North Liberty Planning Commission
Tuesday, June 1, 2021, 6:30 PM

To **City of North Liberty Planning Commission**
From **Ryan Rusnak, AICP**
Date **May 28, 2021**
Re **Request of Red Door Properties I, LLC to approve a Preliminary Plat for a 2 lot subdivision on 2.28 acres, more or less, on property located at the northwest corner of West Penn Street and Penn Court.**

To **City of North Liberty Planning Commission**
From **Ryan Rusnak, AICP**
Date **May 28, 2021**
Re **Request of Red Door Properties I, LLC to approve a Site Plan for a new Scooter's Coffee on approximately .72 acres of property located at the northwest corner of West Penn Street and Penn Court.**

To **City of North Liberty Planning Commission**
From **Ryan Rusnak, AICP**
Date **May 28, 2021**
Re **Request of Hope Presbyterian Church to approve a Site Plan to pave an existing gravel parking lot and add new paved parking on approximately 1.78 acres of property located on the east side of North Front Street approximately 150 feet north of North Dubuque Street.**

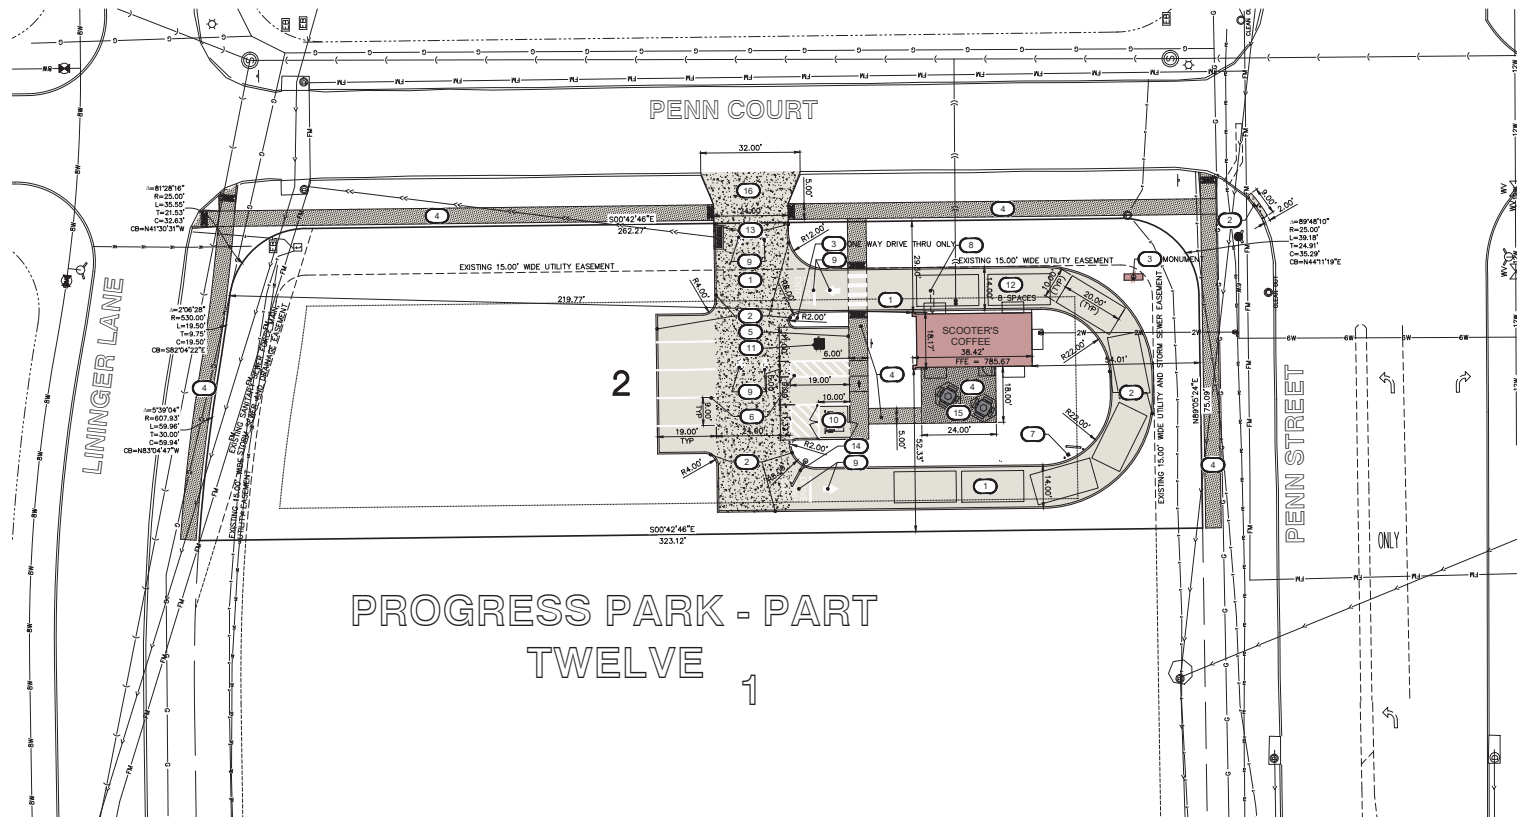
2. That the sidewalk along Penn Court should be designed/constructed at sidewalk elevations and that the sidewalk curb ramps shown at the proposed driveway be removed.

DEMOLITION
PLAN AND
MASS GRADING
AND SWPPP

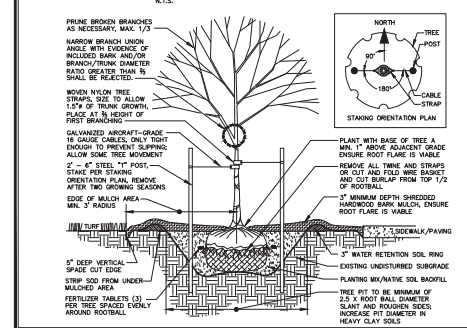
- 1) That the portion of the replaced sidewalk toward the north end of the property be 5 feet in width with a one panel tapering transition.
- 2) That the curb cut at the north driveway location be replaced with a storm intake and pipe into the detention basin and that the grading plans allow for the 100-yr storm event to enter the pond.

- 3) That the driveway jointing detail be revised to follow North Liberty's Supplement to SUDAS. A note has been added on sheet 1, but the detail still allows the contractor an option.

- 4) That there be two 100-year storm routings through the detention basin such that one shows flows with the perforated riser as the control and one shows the 6" tile line as the control. Revise the stormwater report as necessary.
